University of South Carolina
Controllers Suite Renovations
1600 Hampton Street-6th Floor
Columbia, South Carolina

March 7, 2014

ADDENDUM No. 1

1 SIXTH FLOOR-DEMOLITION PLAN
1/8" = 1'-0"

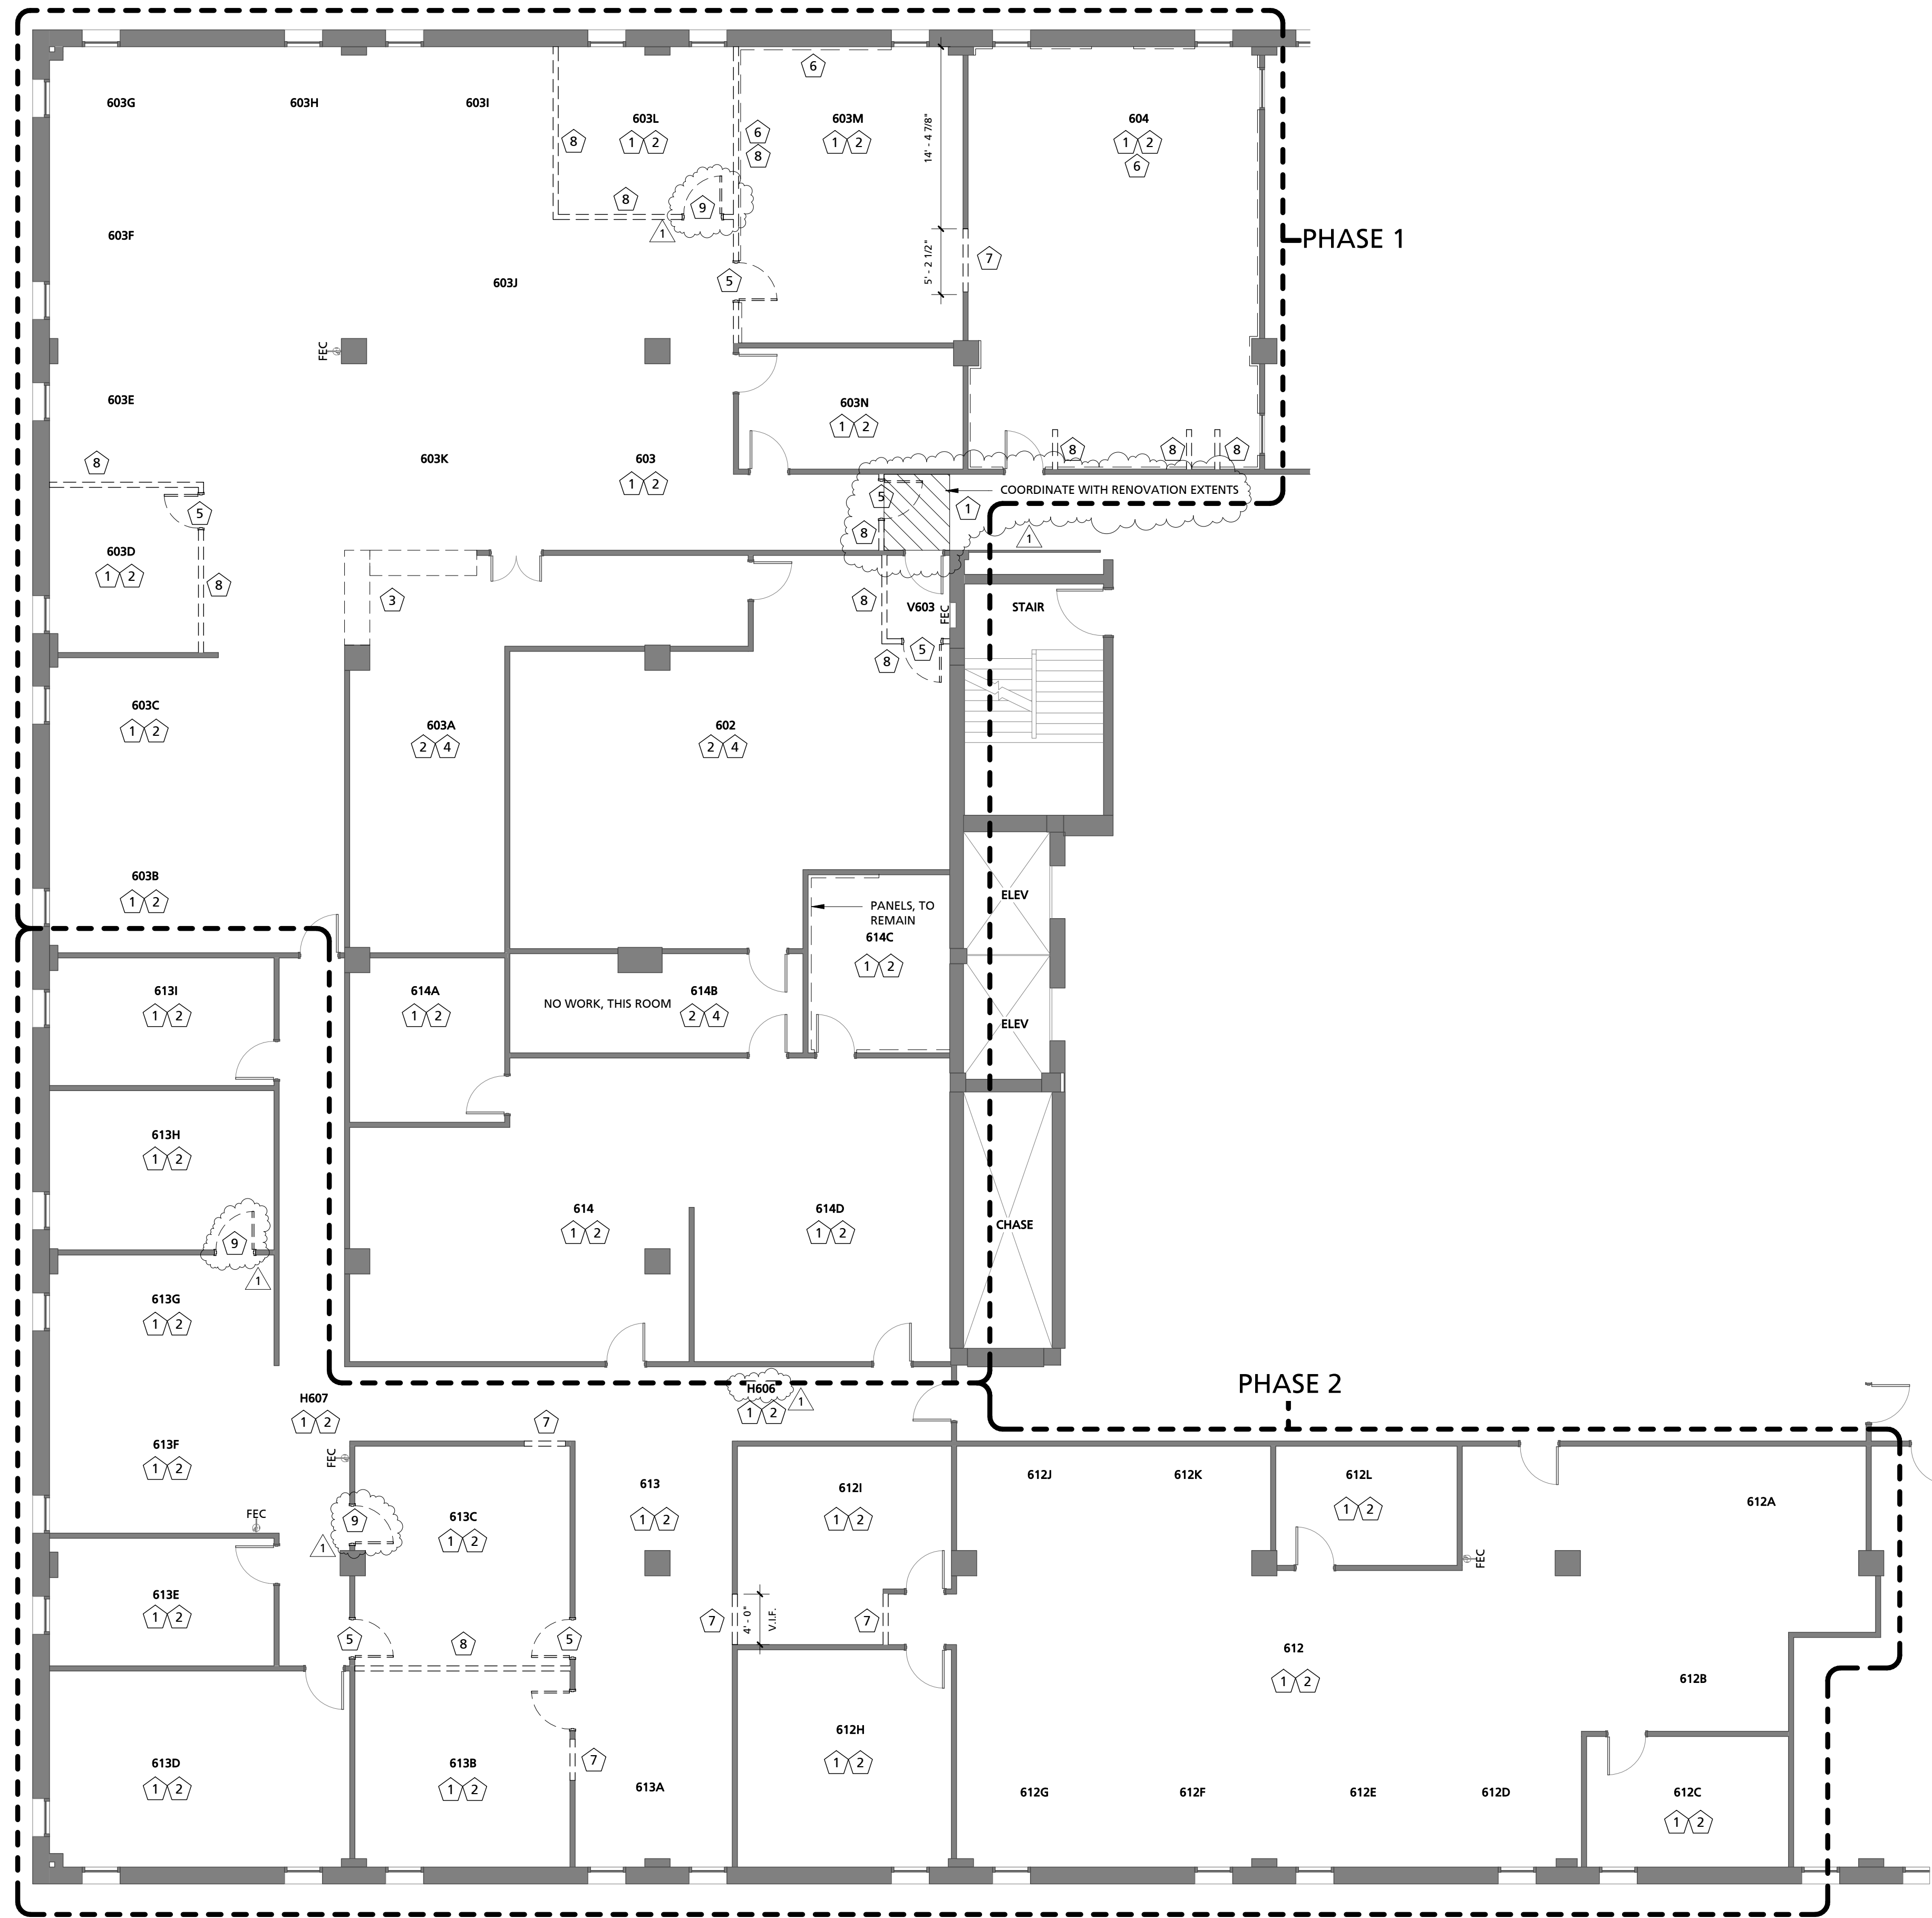
1. Reference Sheet AD101 – DELETE Sheet AD101 dated 02.24.14, ADD in its place Sheet AD101 dated 02.24.14, revised 03.07.14, see attached.
 - a. Key Plan: True North Added

- b. Detail 1: Misc Notes added and revised
 - c. Demolition Tags and Notes: Note 9 added
2. Reference Sheet AD102 – DELETE Sheet AD102 dated 02.24.14, ADD in its place Sheet AD102 dated 02.24.14, revised 03.07.14, see attached.

1 SIXTH FLOOR-DEMOLITION PLAN
1/8" = 1'-0"

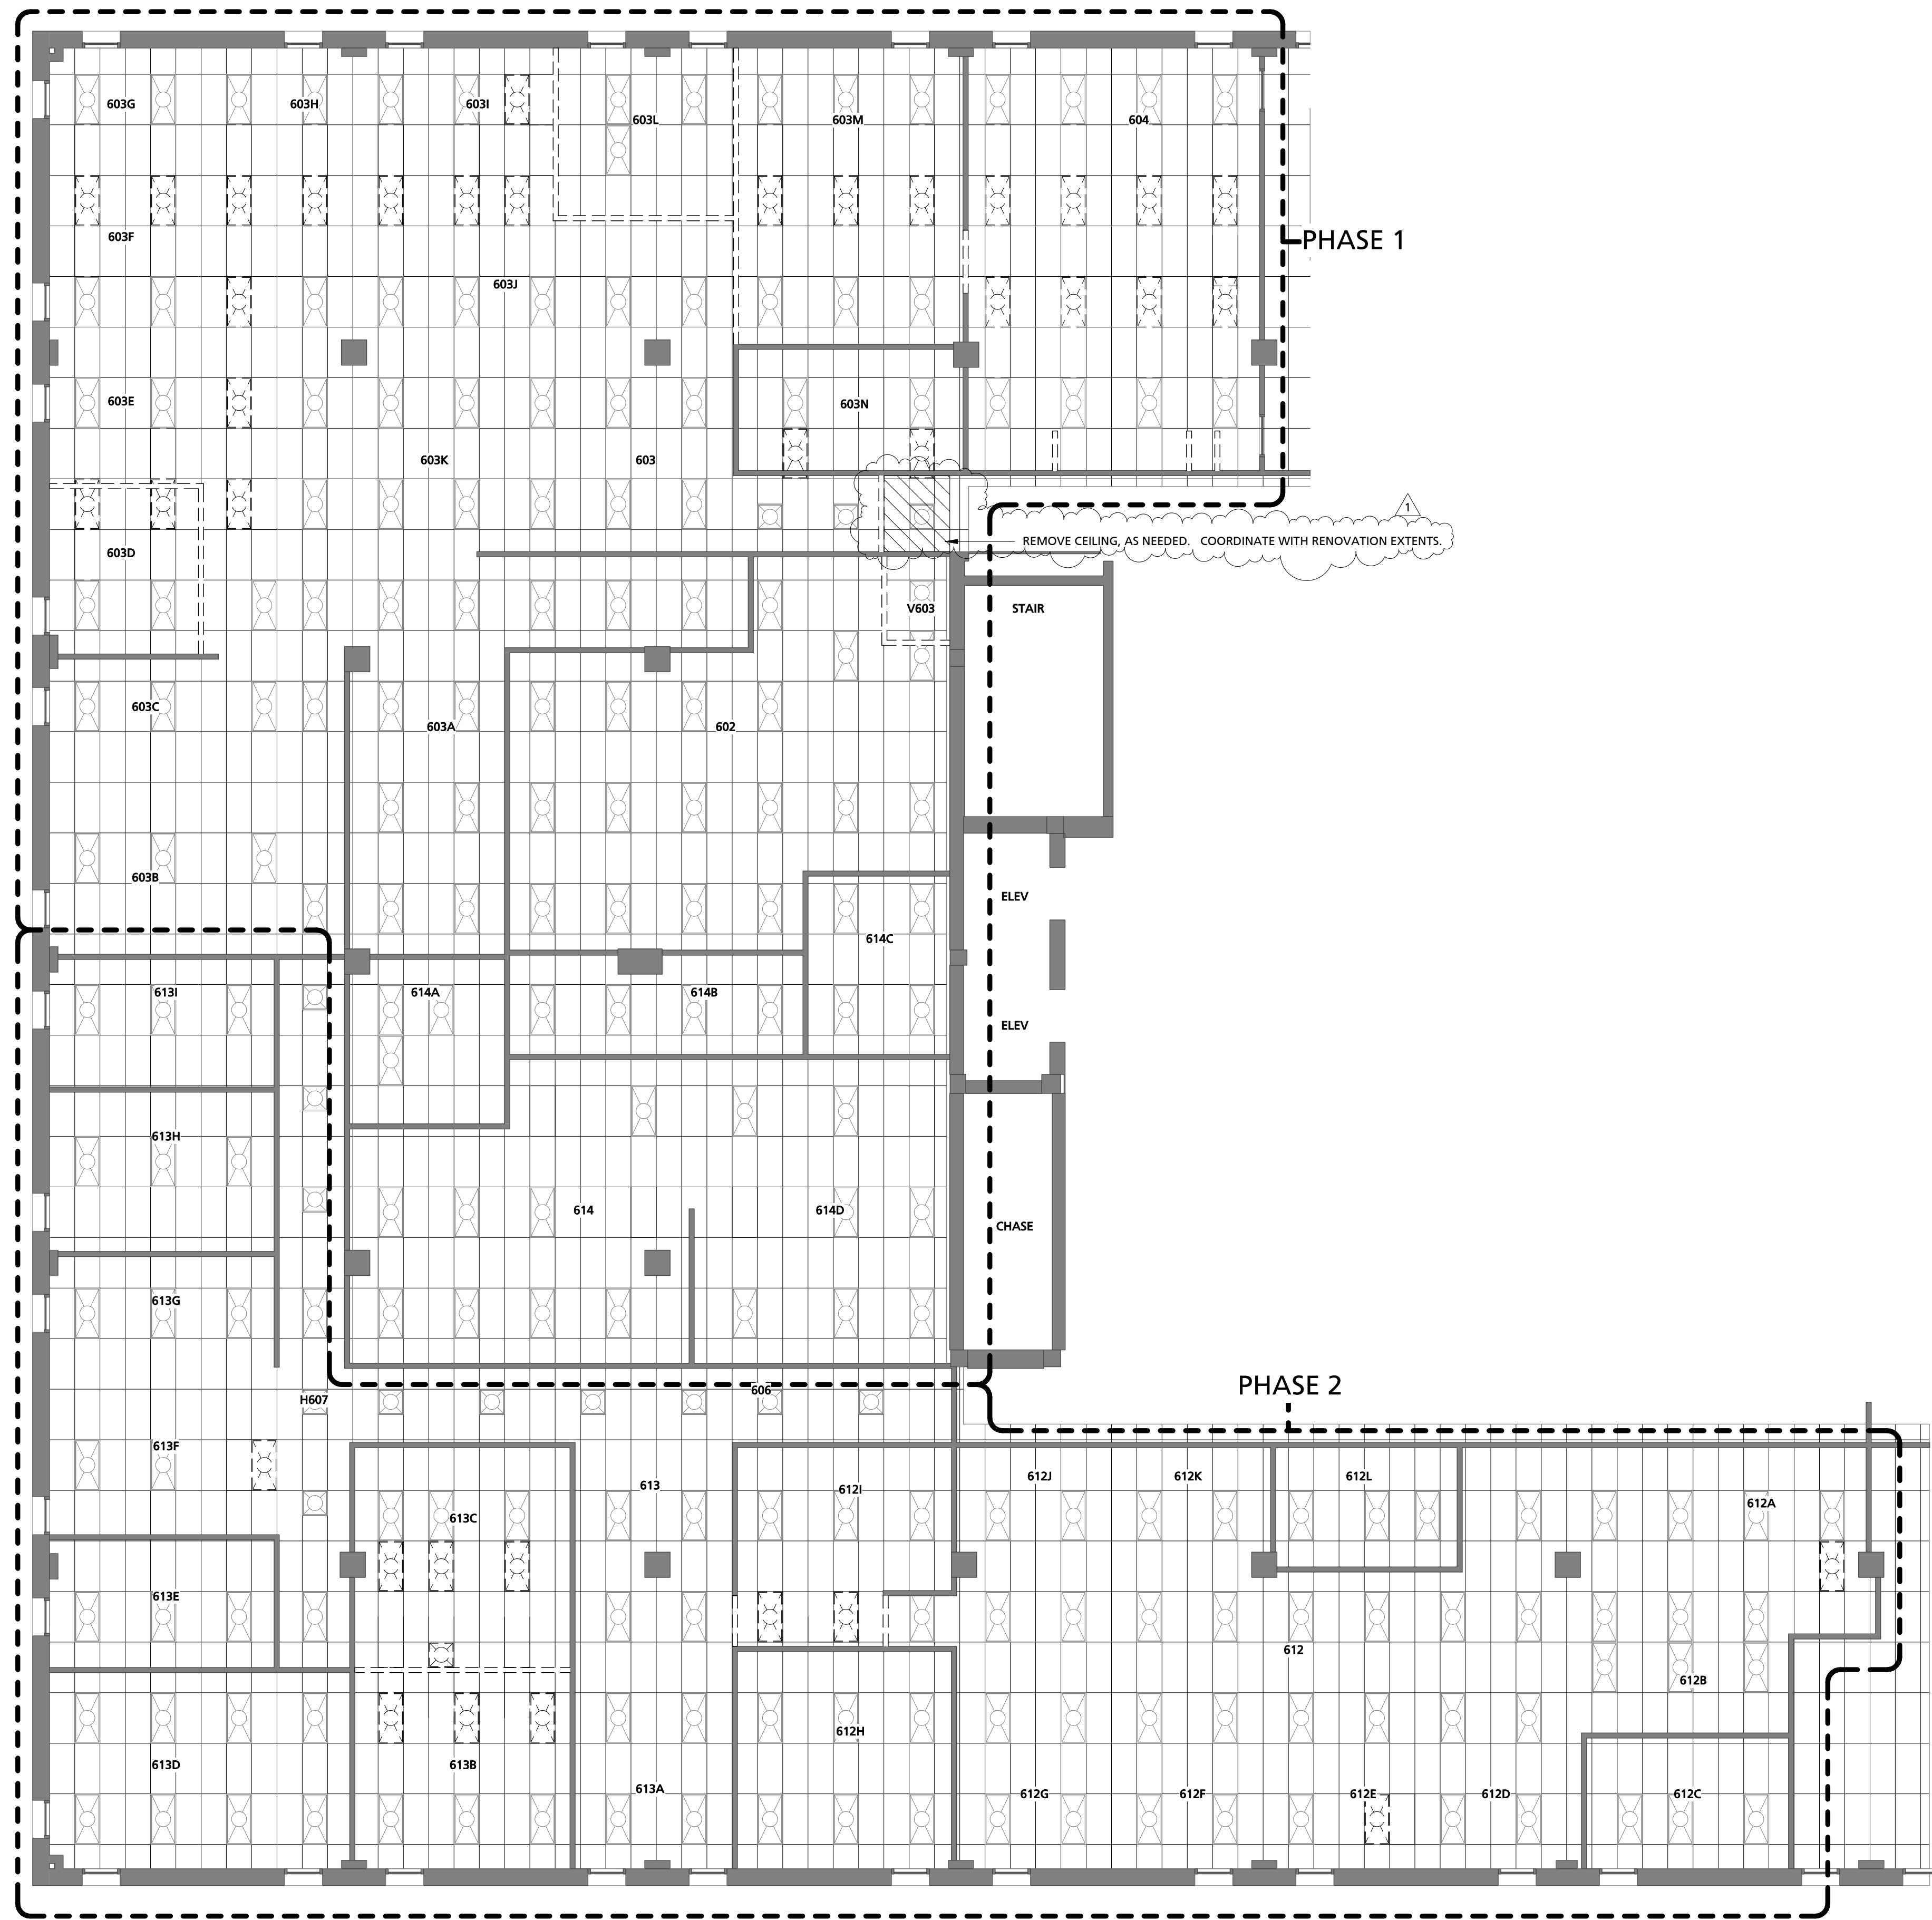
- a. Key Plan: True North Added
 - b. Detail 1: Notes added
3. Reference Sheet A101 – DELETE Sheet A101 dated 02.24.14, ADD in its place Sheet A101 dated 02.24.14, revised 03.07.14, see attached.

1 SIXTH FLOOR-RENOVATION PLAN
1/8" = 1'-0"

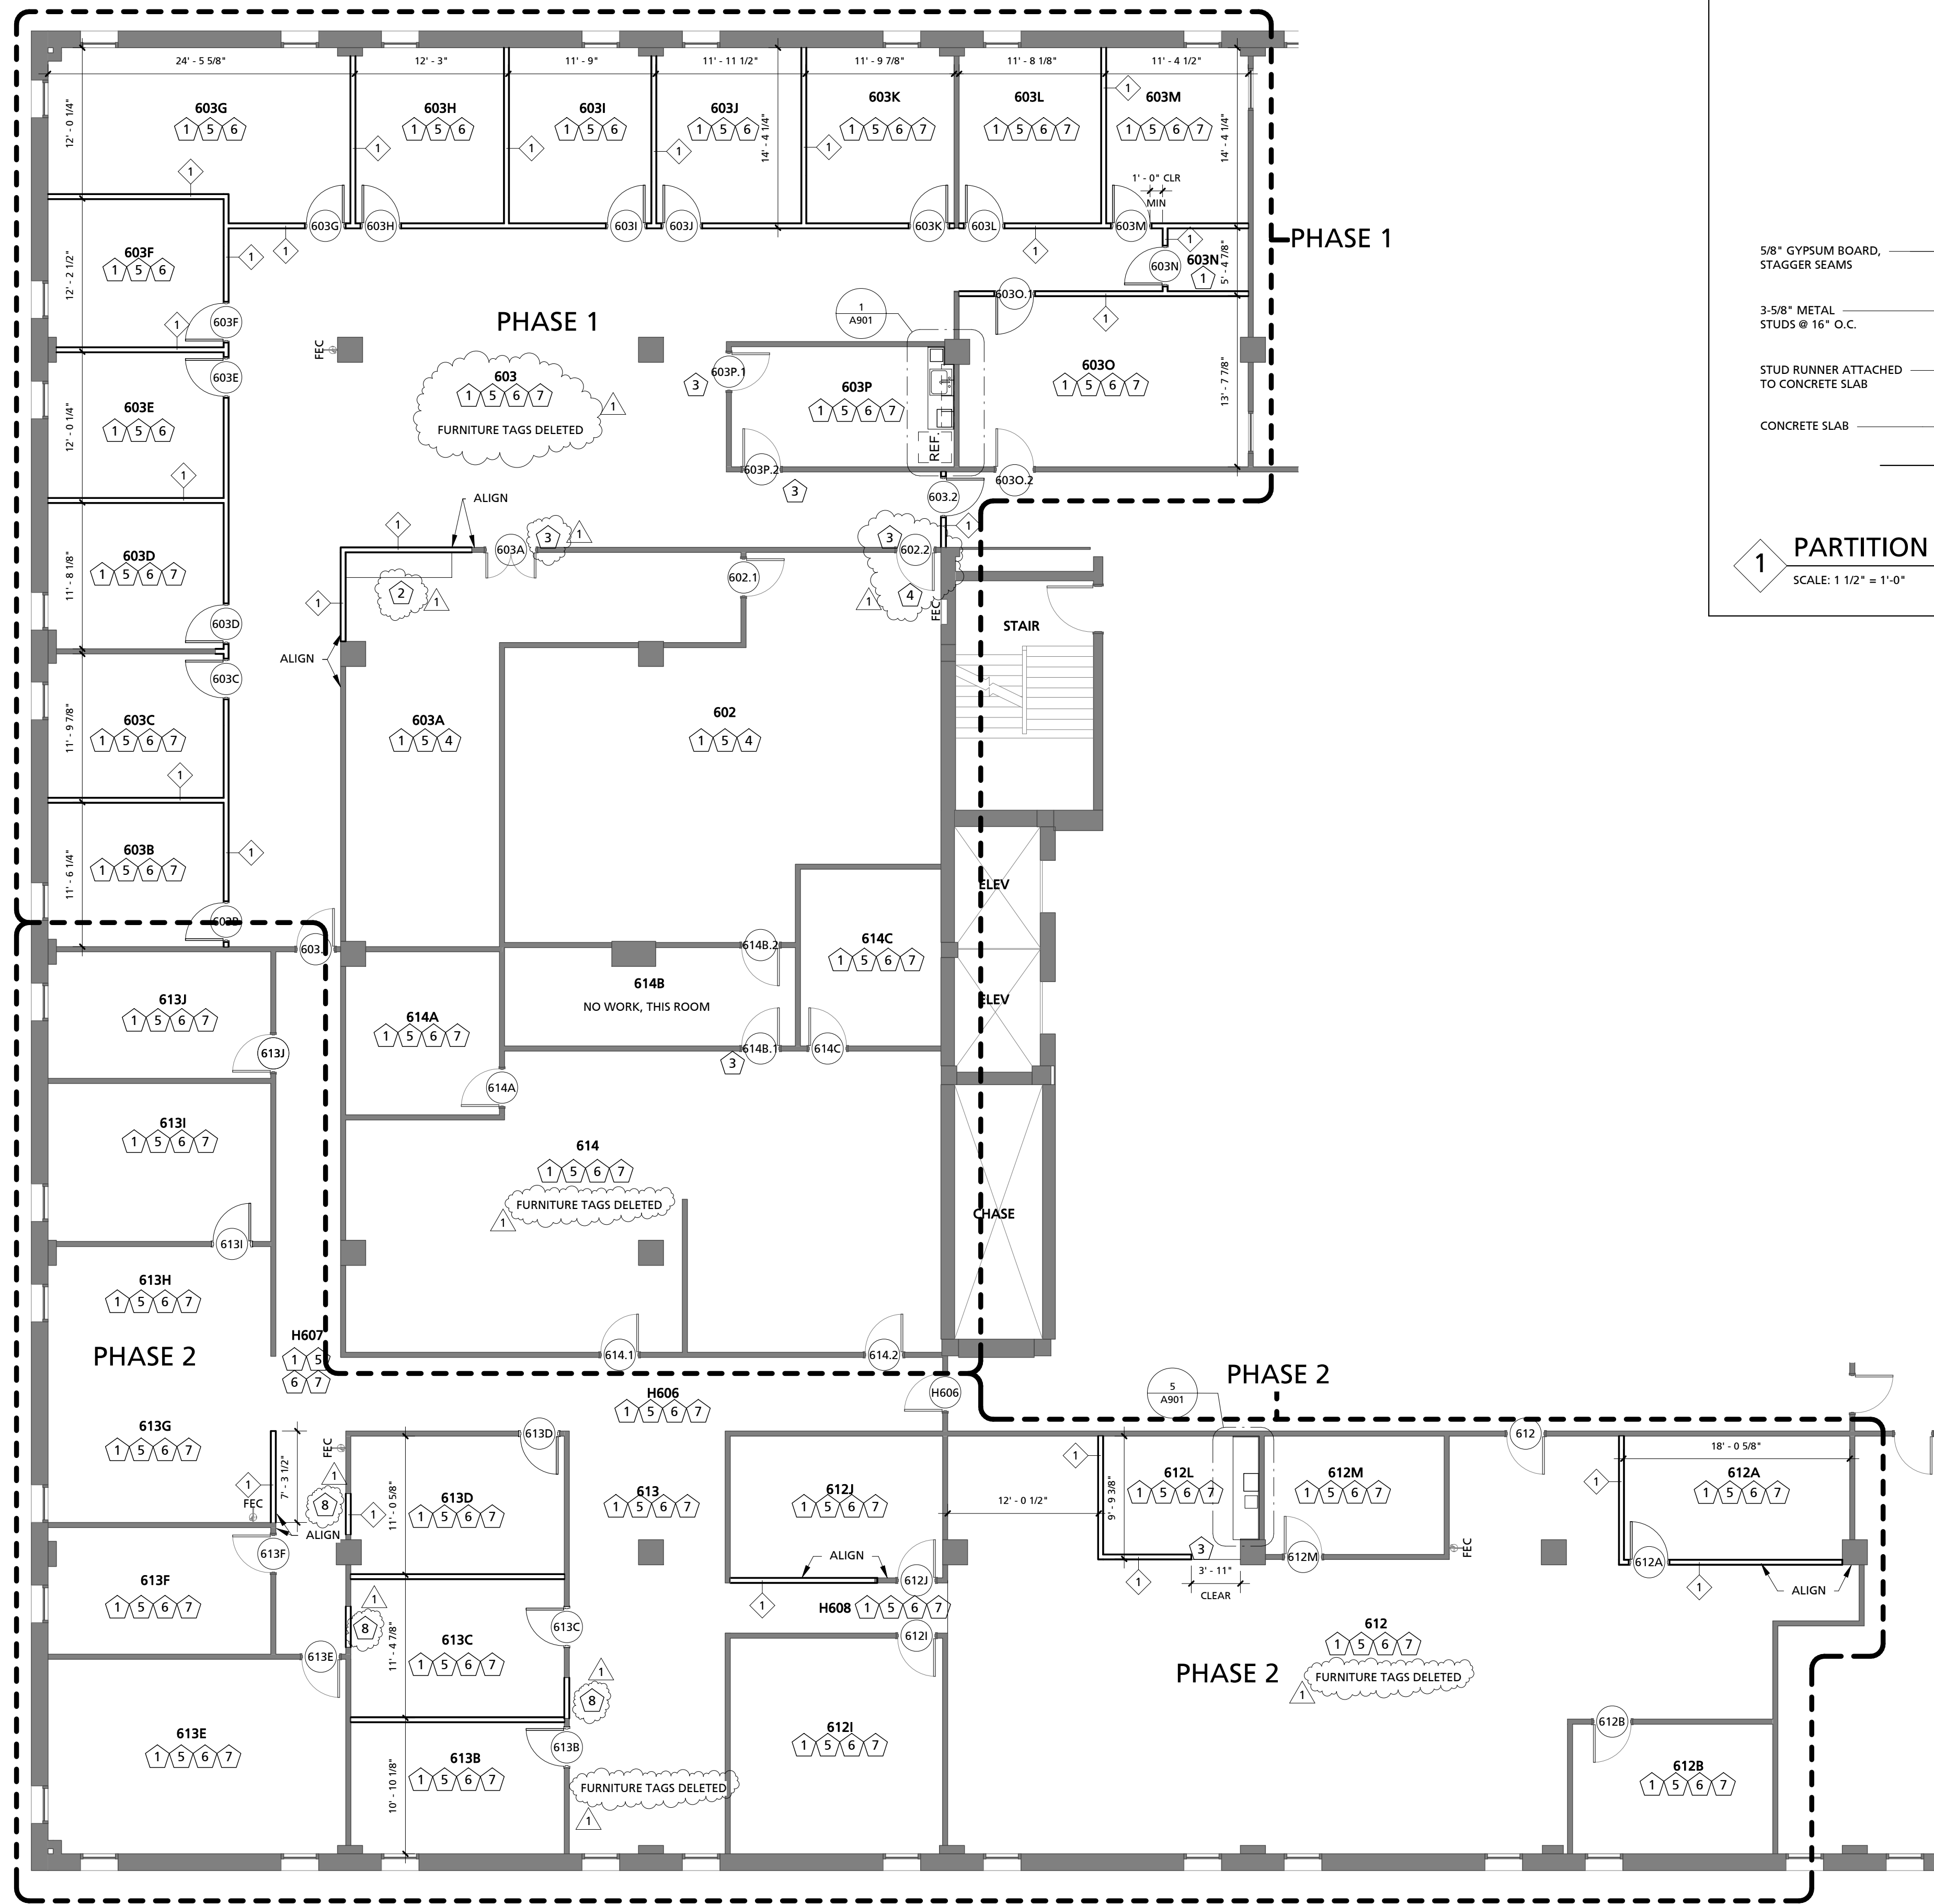
- a. Key Plan: True North Added
 - b. Detail 1: Renovation notes added; furniture tags deleted
 - c. Renovation Tags and Notes: Note 7 clarified
4. Reference Sheet A201 – DELETE Sheet A201 dated 02.24.14, ADD in its place Sheet A201 dated 02.24.14, revised 03.07.14, see attached.
